Commonwealth Edison
One First National Plaza, Chicago, Illinois
Address Reply to: Post Office Box 767
Chicago, Illinois 60690

April 19, 1977

Subject: Dresden Station Units 2 and 3
Quad-Cities Station Units 1 and 2
Mark I Containment - Drywell to Torus
Differential Pressure Instrumentation
NRC Docket Nos. 50-237/249/254/265

Δ P PUMP-BACK SYSTEM MODIFICATION

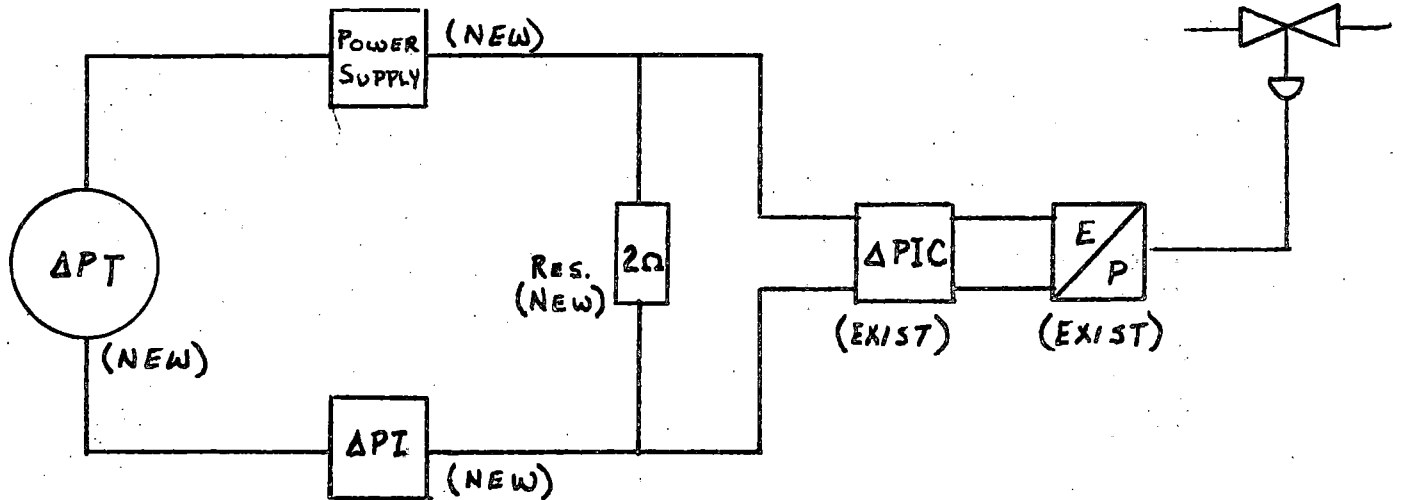
The modification includes the substitution of a differential pressure transmitter (ΔPT) for the existing drywell and torus pressure transmitters (90X-3) and a digital differential pressure indicator (ΔPI). A schematic of the modified system is provided in Figure 1 (attached). Also provided in the Figure are instrument accuracies for the new equipment. The modified system will provide continuous redundant indication of the drywell-torus ΔP , and will be accurate to within 0.1 psid as recommended by the NRC in Reference (a).

* ΔPT : 0 to 150" H₂O 0 to 5.42 PSI adjustable to
0 to 3 PSI input 4 to 20 MA output
Accuracy .2% of calibrated range

* ΔPI : Readout 0.00 to 3.00 PSI
Accuracy .1% range

*Power: 24 VDC output - 115 VAC input
Supply

*Resistor: 2Ω /1% tolerance
